ADDENDUM NO. 2

Project: Miracle of Hickory Park - Modification
City of Hickory, North Carolina

Date: September 21, 2026

Miracle of Hickory Park – RFIs

C200

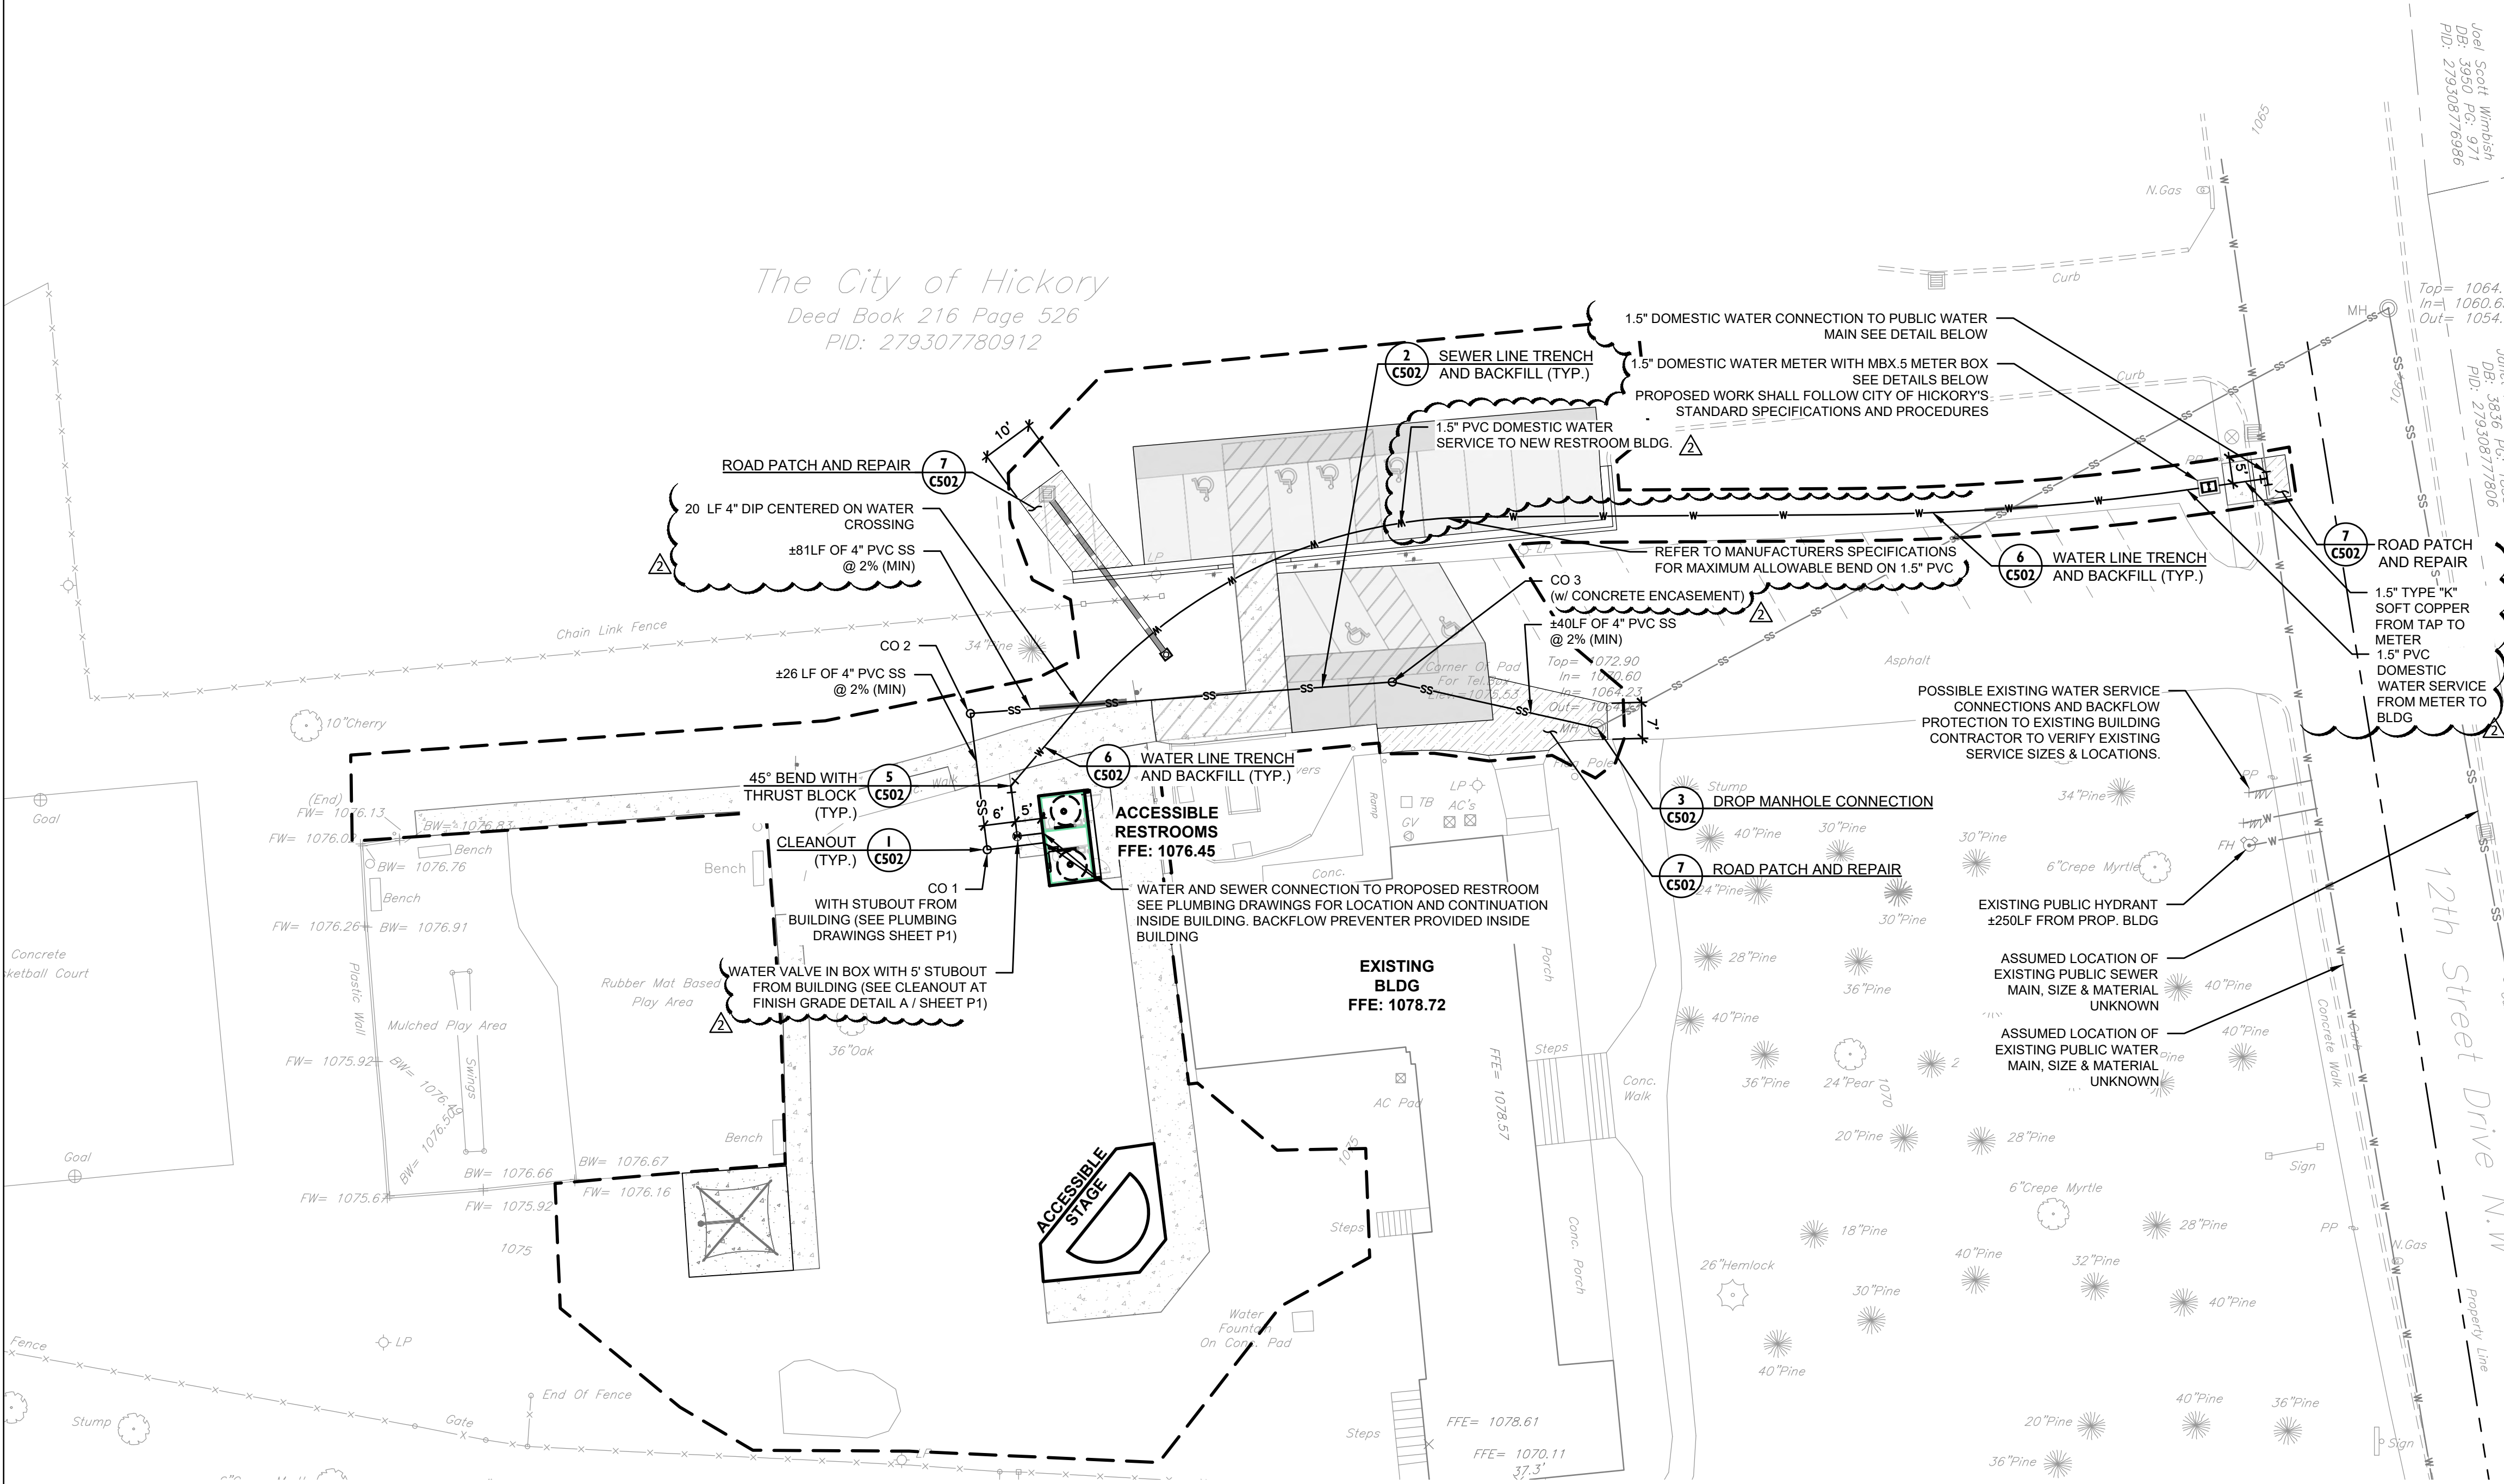
1. Based on a site meeting held on 9/18/26 between City of Hickory Engineering and City of Hickory Utilities we are going to need to run a new 1 ½" water service line from the watermain on 12th St. Dr. NE to the new restroom building. Preferably with the alignment staying primarily in the grass strip between the Music Factory parking lot and the Army Reserve parking lot. This will require a new water tap and meter. See revised sheet C400. The backflow preventor and pressure reducing valve are shown on the revised plumbing sheet P1.
2. The line items for the restroom building have been split into two items on the bid form.
3. A series of questions have been received and are responded to below:
